MATRIX		Service Bulletin Announcing Matrix ClimbMill Improvements	
Effective Date: April 16, 2015	Models Affected: C-3X-F (CS21), C-5x/7x-01-F (CS17/CS22/CS23/CS24)		Bulletin Num. NB-1505004
Prepared by: Eric Chen

ClimbMill Improvements

Case 6: Front shield – Matrix cover screws are changed to rustproof stainless steel

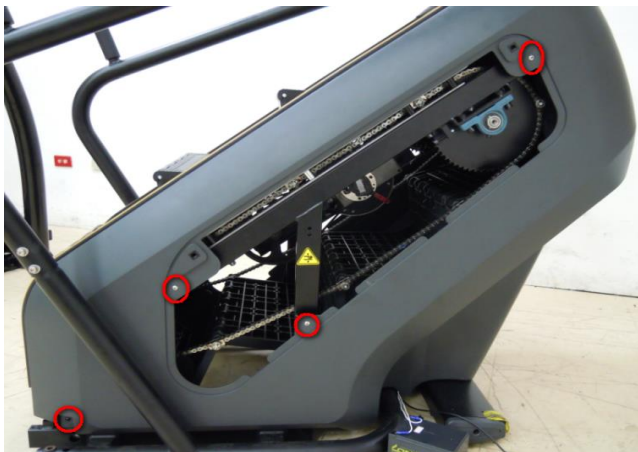
Old – Non-stainless steel screw

New – Stainless steel screw

Case 8: Side cover - Location hole on side covers is removed

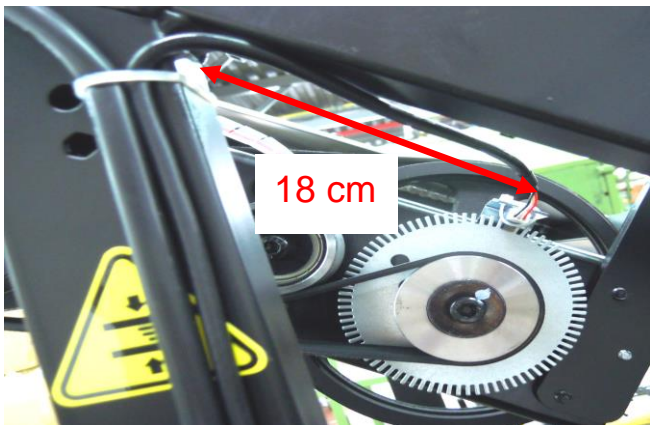
Old – Side cover with location hole

New – Side cover with location hole removed

Case 11: Drive set – Brake pad in the center fixed (for spare part only)

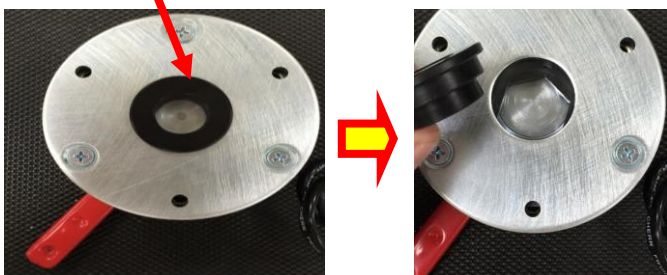
Note: You must remove the fixing sleeve after you assemble DC brake to drive set.

Old – Without fixing sleeve

New – With fixing sleeve

DC brake set (with fixing sleeve) – part no. **1000354903**

Case 12: Drive set – Fan/DC brake wire location modified for easier repair

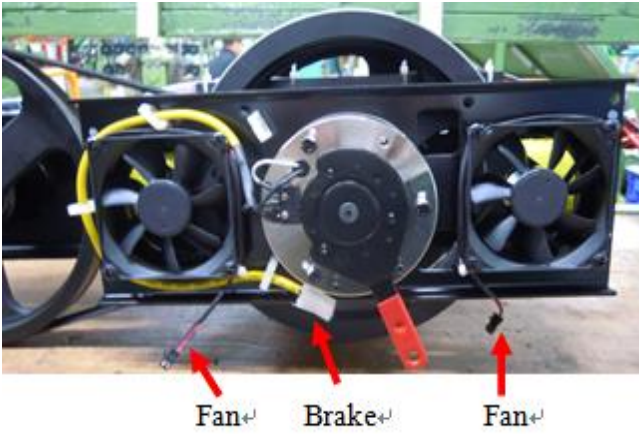
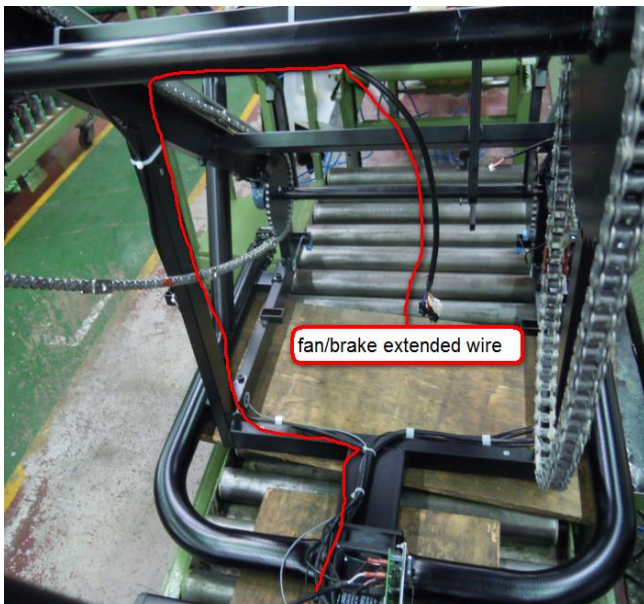
Old – Difficult to perform repair

New – Easier to unplug and fix fan/brake wire

Case 13: Drive set – Brake power cable tube color changed to yellow so it's easy to distinguish

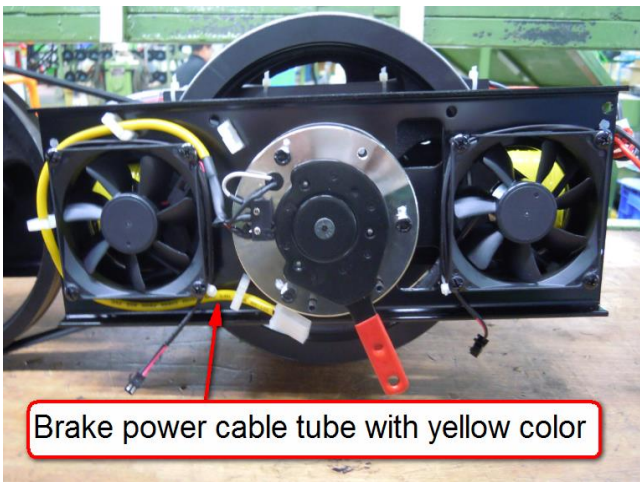
Old – Black brake power cable

Brake power cable tube with yellow color

New – Yellow brake power cable

Case 14: Drive set – Fixing plate screw type modified for easier disassembly

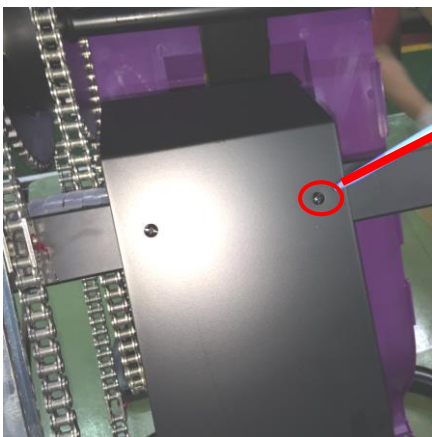
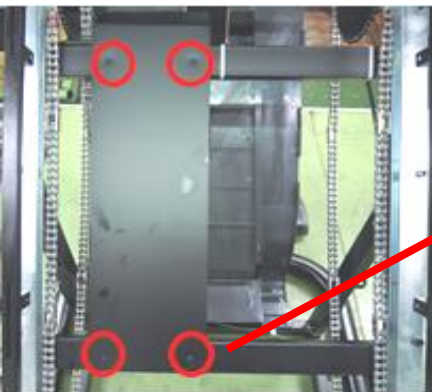
Old – Oval crisscross screw

New – Socket head screw

Case 15: Hand grip – Hand pulse wire location changed to prevent wire damage

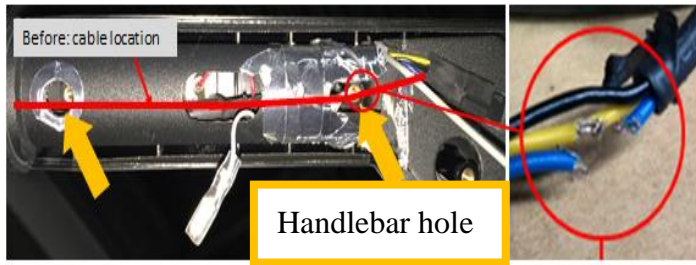
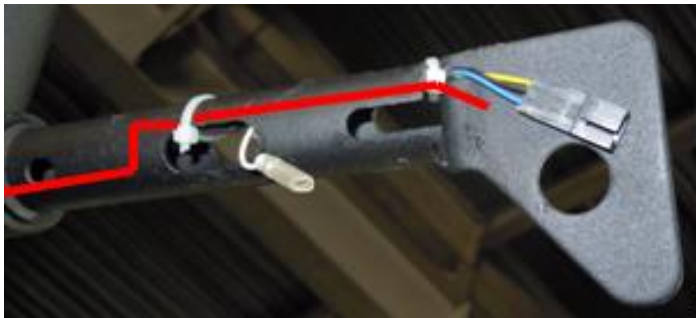
- Old –
- There is no cable tie to keep the hand pulse wire in place.
 - Hand pulse wire goes over the handlebar hole. The wire would be damaged when hand grip cover is assembled.

- New –
- Add two cable ties to fix the hand pulse wire in place.
 - Hand pulse wire doesn't go over the handlebar hole.

Case 17: Design a brand new hand grip/overlay/keypad (TBD)

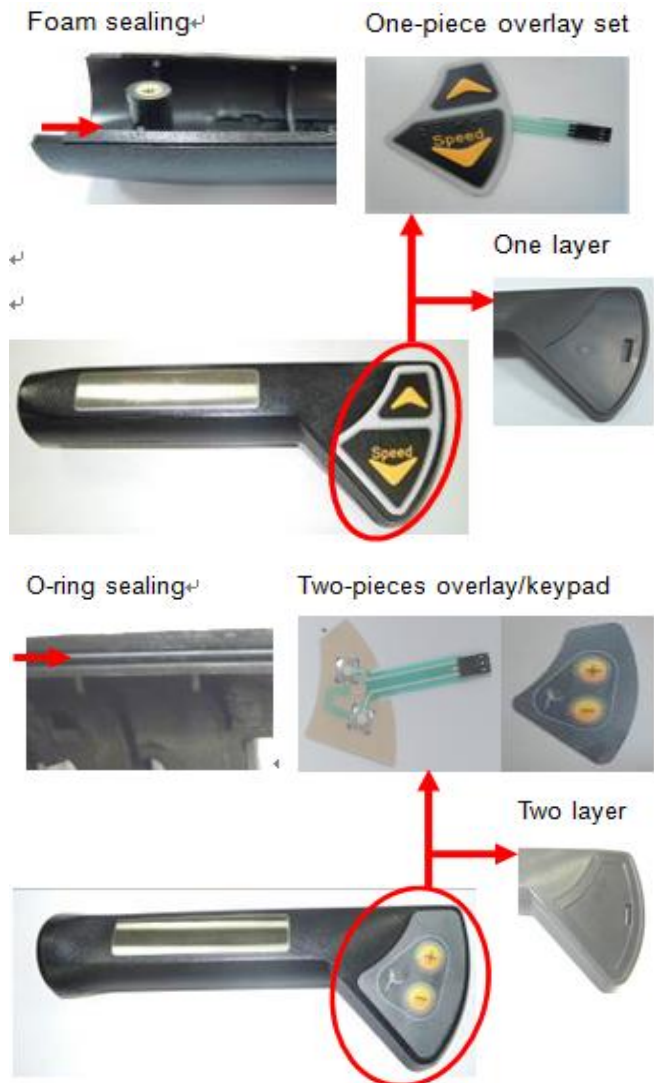
- One-piece overlay set
- Hand grip with foam sealing

- Two-piece-with new overlay/keypad.
- Brand new hand grip with O-ring sealing.

Note: The new and old hand grip/overlay/keypad are not compatible. If the old hand grip set is defective, you must order and replace two new hand grip sets (parts no. #1000359150/ 1000359164) at the same time.

Case 19: Side rail – Modify the side rail width

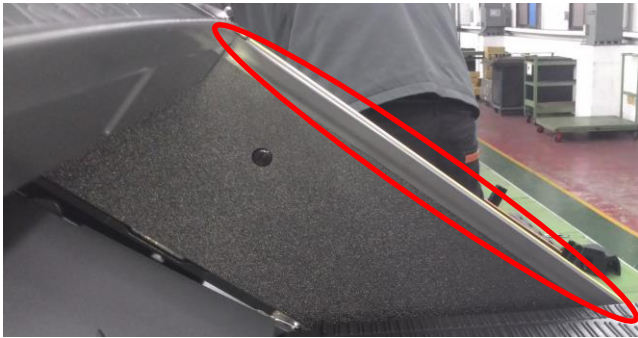
Old – Narrow side rail

New – Wider side rail

Case 20: Guide rail – Guide rails are galvanized to be rustproof

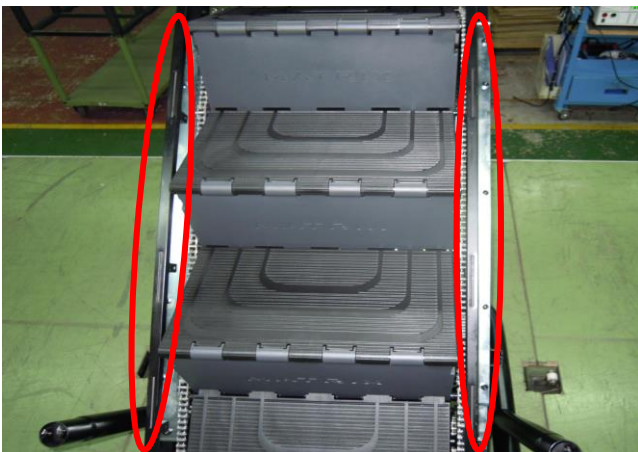
Old – Guide rail with anti-rust grease

New – Galvanized guide rail

Case 21: Frame IR – Screws are changed to galvanized socket head screws (easier to disassemble and rustproof)

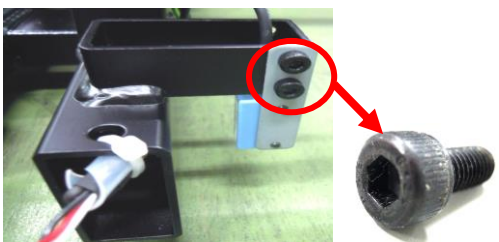
Old – Oval crisscross screw

New – Galvanized socket head screw

Case 23: Cover plate – Add drain route on the cover plate

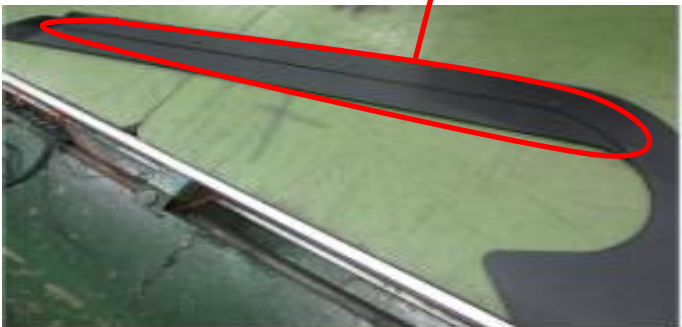
Old – Cover plate without a drain route

New – Cover plate with a drain route
